ENGINEER'S DAILY REPORT

04-SF-80-13.2/13.9
 Contract No. 04-0120F4
 {SAS Superstructure}

❖ **RFI # 707R2 Issue:**

REQUEST FOR INFORMATION (RFI) – ABF&SUB.RFI No.: RFI-BLI-000050R02 (ABF RFI 707) Submitted by: _____ Page(s): 1RFI Date: 7/16/07 Contact Name: Anna Lee Phone No. (415) 896-6072Subject: Panels and Pullboxes at Tower Platform 53.85References: RFI 707Response required by: 7/30/07 (date) Response affects critical path activity? X YES NO**Description:**

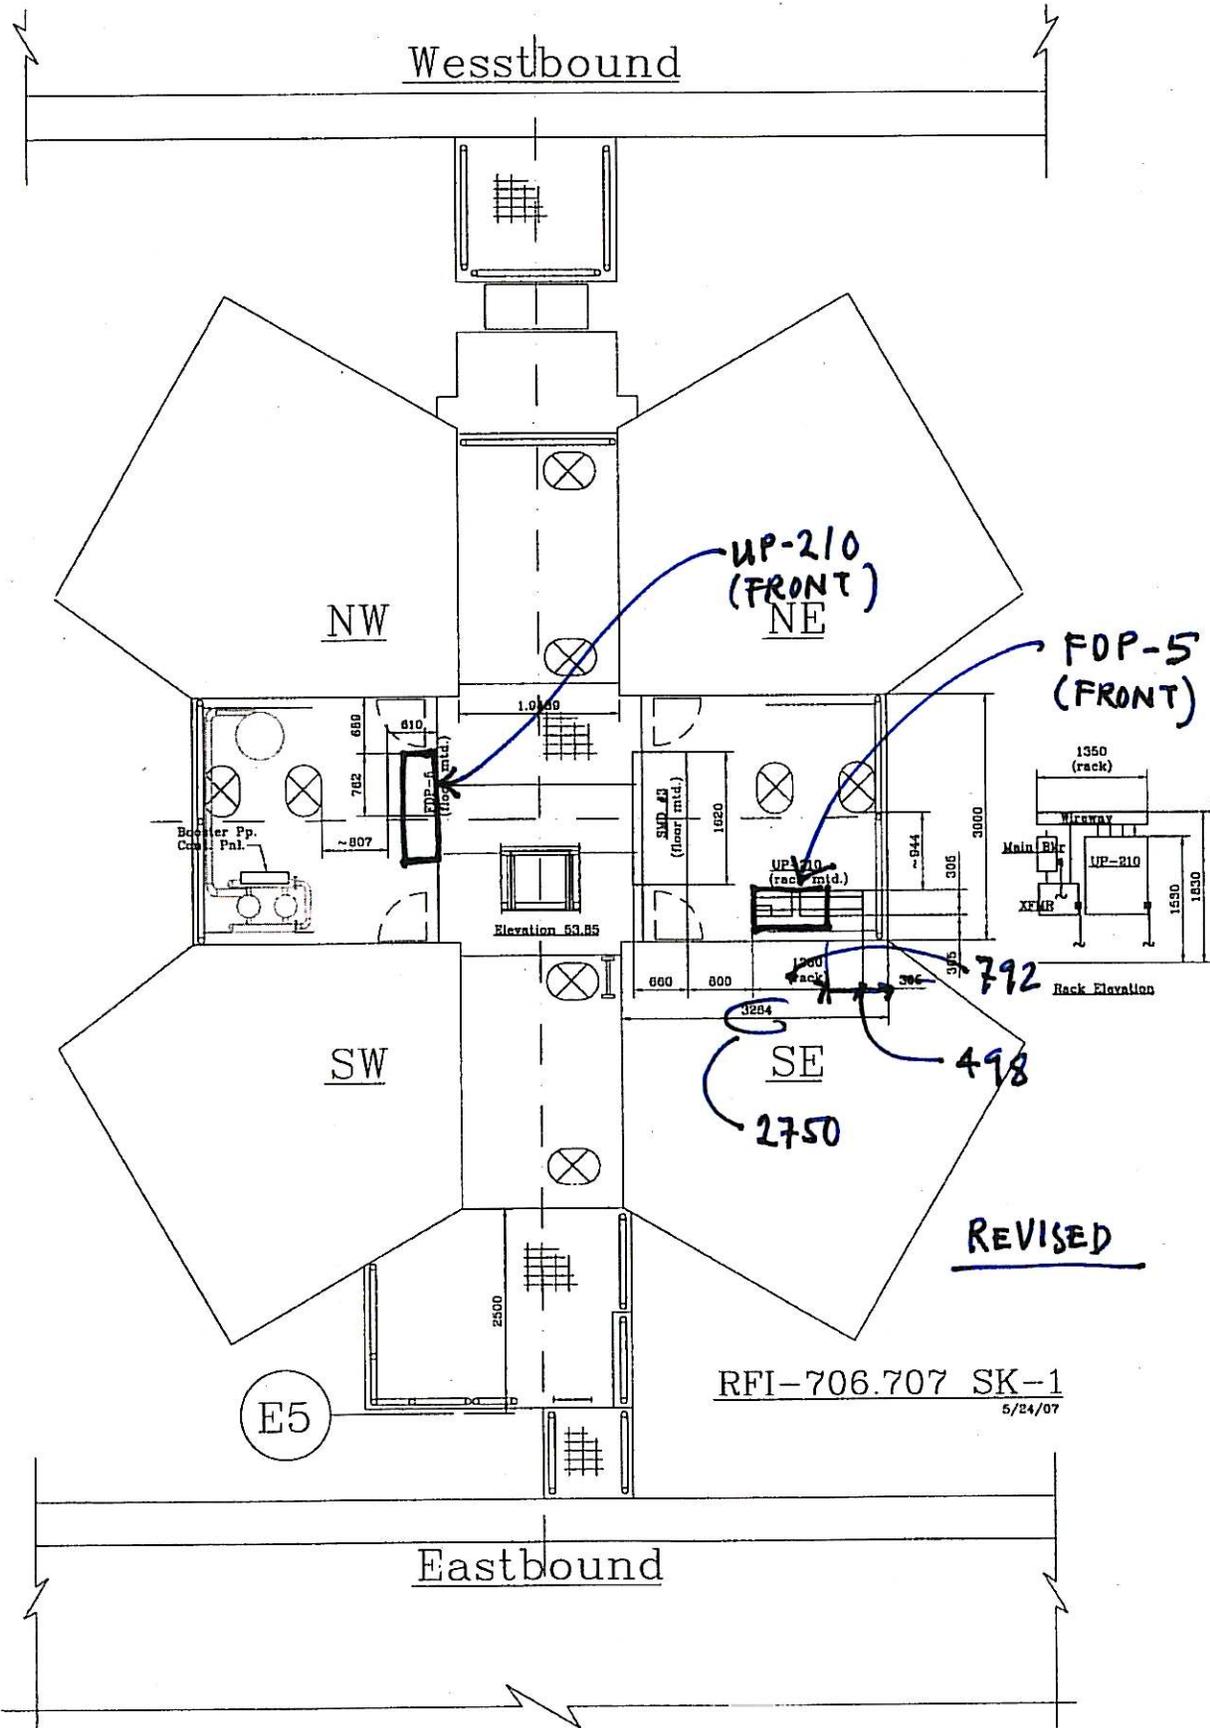
I was outnumbered on yesterday's telecom and realize after (overnight) that what I agreed is going to be "appearance problem".

The reason for not locating the UP-210 behind the railing is because, the UP-210 rack, and all the spaghetti conduits going to the wire way shall be visible from the roadway level at 53.85.

Locating the UP-210 and rack between the NW and SW skin plate, opposite location from the strong motion panel shall hide the electrical installation from the roadway level. In addition, the FDP-5 which is floor mounted equipment (762 wide) maybe a lot smaller when we get all the information which most likely become a wall mount.

So, my conclusion, the revise arrangement is the way to go. Conduit rerouting, to avoid crossings is not a monumental task to change but the "appearance" shall be forever on the bridge.

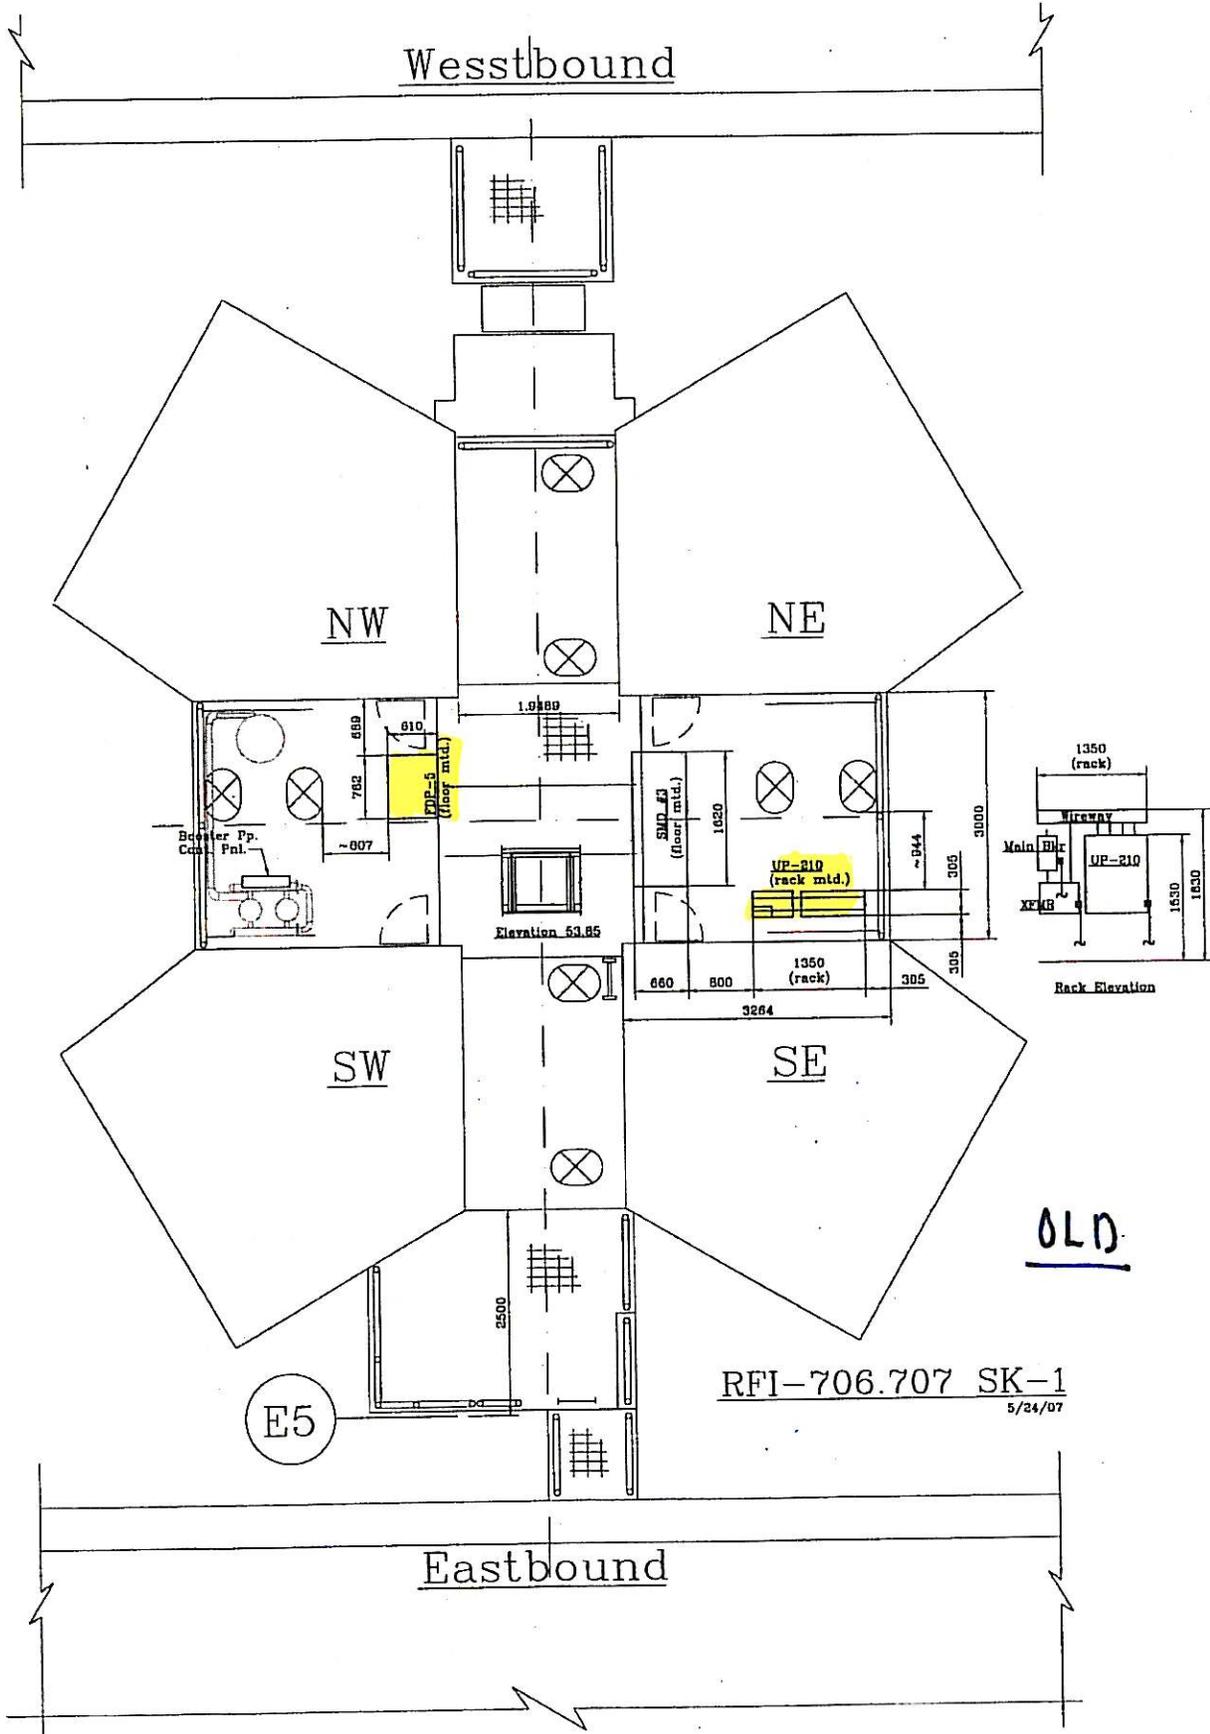
- Contrary to the first statement, tower skin penetrations and attachments changed due to elevation changes for conduit routes. Equipment relocation to different quadrants resulted in previously run north-south conduits changing to east-west conduits.

- Utility panel UP-210 submitted separately as main breaker, transformer, and panelboard per the 4th paragraph (Submittals 174, 175, 176) has not been approved. It was stated in the 7/10/07 MEP meeting that a re-design of UP-210 is in progress.

- Pullbox 914x762x406 sized per NEC code 314.28, mounted on the SW-E plate, has been added in lieu of PB-2D and PB-3A deleted by the 5th paragraph, as the multitude of large conductors can not be routed through the 8x8 wireway. Additionally, Circuit A-3057-1 pier lights has been deleted from Conduit #3281 carrying sump pump conductors from UP-210. This circuit has been added to Conduit #3364 routed direct to the SW-A face.

- Sketch RFI-707-7.07 SK-1 lays out UP-210 using an incorrect dimension of 3264 mm for the SE-A plate. Please issue a corrected layout using 2750 mm for the A plate.

To avoid further re-work of the electrical information for the tower shop drawings, please consider future responses that keep equipment in the same quadrant without raising elevations.
